FLAGLER BEACH Beachwalk 30% Schematic Design

Beachwalk Project Summary

- 2. Comments from June 26th Commissioners Meeting
- 3. Schedule
- 4. Next Steps

South Elevation

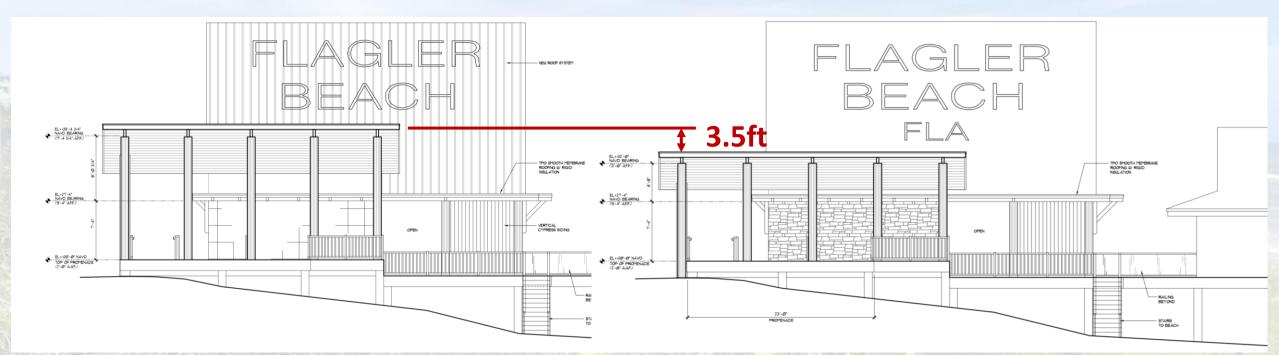
Eliminate the sloped roof elements above the re-built facilities (flat roof or minimal pitch to ensure visibility of 'A'-frame "Flagler Beach FLA" lettering).

- Sloped roof has been lowered.
- Slope has been reduced to the minimum allowable slop.
- Total roof height decrease of ~3.5 feet.
- Roof height and visibility of the A-Frame lettering similar to existing.

East Elevation

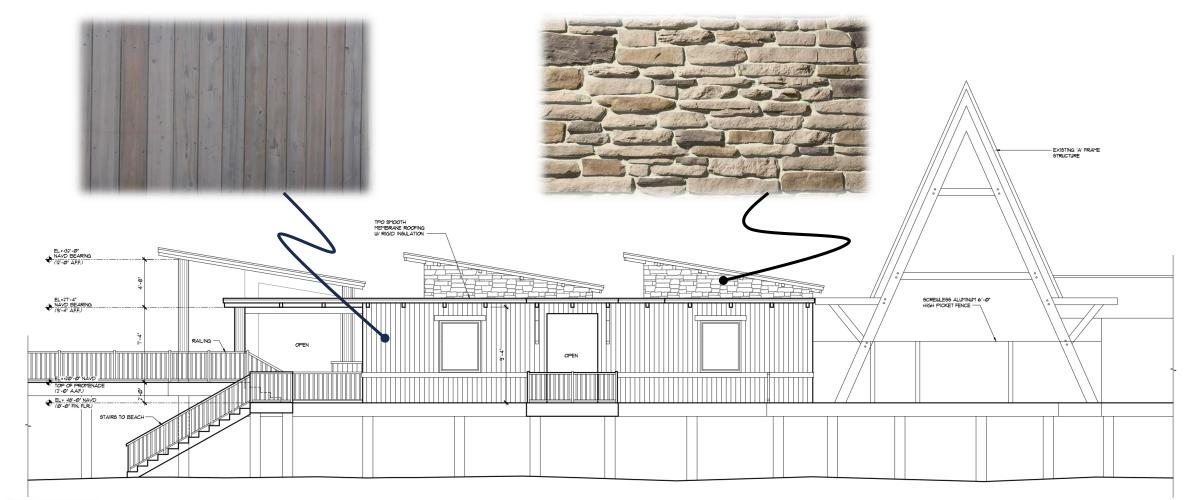
Eliminate stone/shell exterior façade.

- Original restroom building stone/shell tile façade replaced with a manufactured stone veneer
 - More cost effective
 - Aligns with mid-century modern design
- Original commercial space and radio studio siding remains cypress
 - Durable timber siding
 - Aligns with mid-century modern design

Restroom Benches

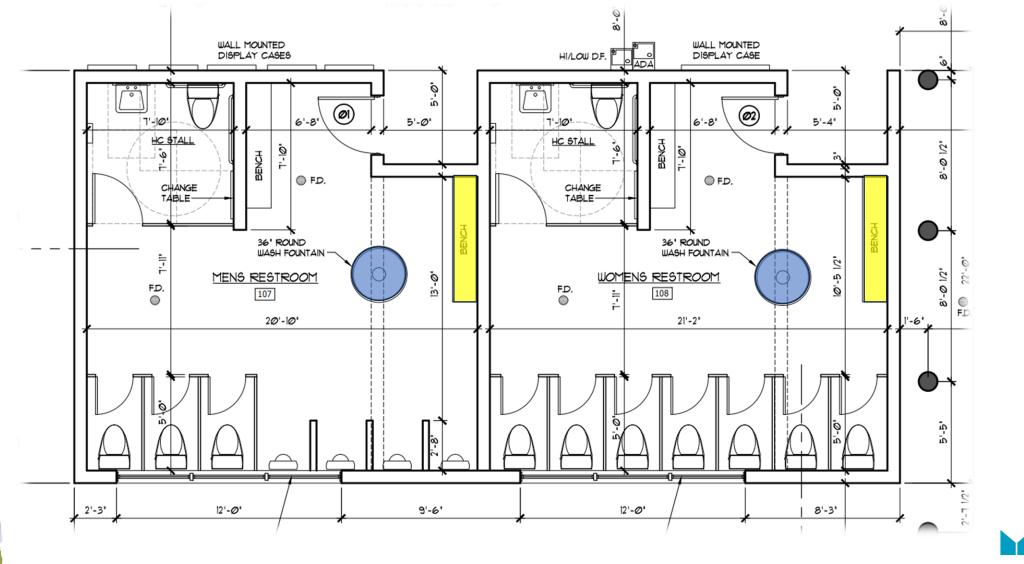
If the circular sink remains as a design feature, provide shelving to accommodate users' accessories/equipment (perhaps southern wall of each restroom?).

- Proceed with the circular sinks
- Include benches along the southern wall inside the restrooms

Promenade Access Stairs

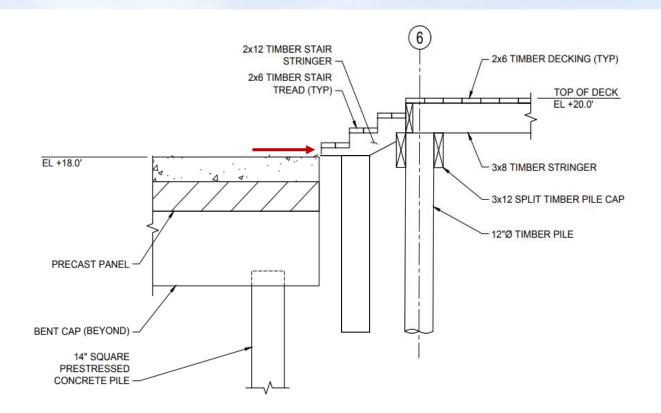
A late unshared comment from Commissioner Cooley expressed concern regarding the sustainability/vulnerability of the northernfacing stair structure at the southeast corner of the facility.

- Stairs will shift a little south
- No longer bearing on concrete foundation
- Separate structures
